Robinson Helicopter Company

MANDATORY SERVICE BULLETIN SB-12

SUBJECT: Removal of sharp edges in the Angular Latch Portion of

A628-1 and -2 Seat Harness Assembly.

DIAGRAM OF ANGULAR LATCH

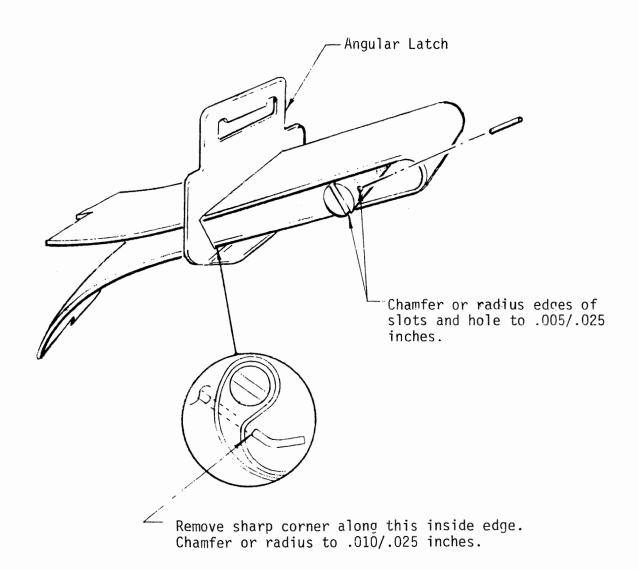
Some fraying of the webbing has been observed at the angular latch. In one incident, the webbing failed in an accident. The failure may have been related to a sharp edge on the round knurled locking bar or the latch plate.

- 1. Remove the locking bar by pressing the roll pin halfway out using a 3/32 dia. punch.
- 2. Chamfer or round edges of the slots and hole in the locking bar and also the inside edge of the latch plate as shown in the view on the attached sheet, using a file or hand grinder.
- 3. Reinstall the locking bar, pressing the roll pin flush with the surface.
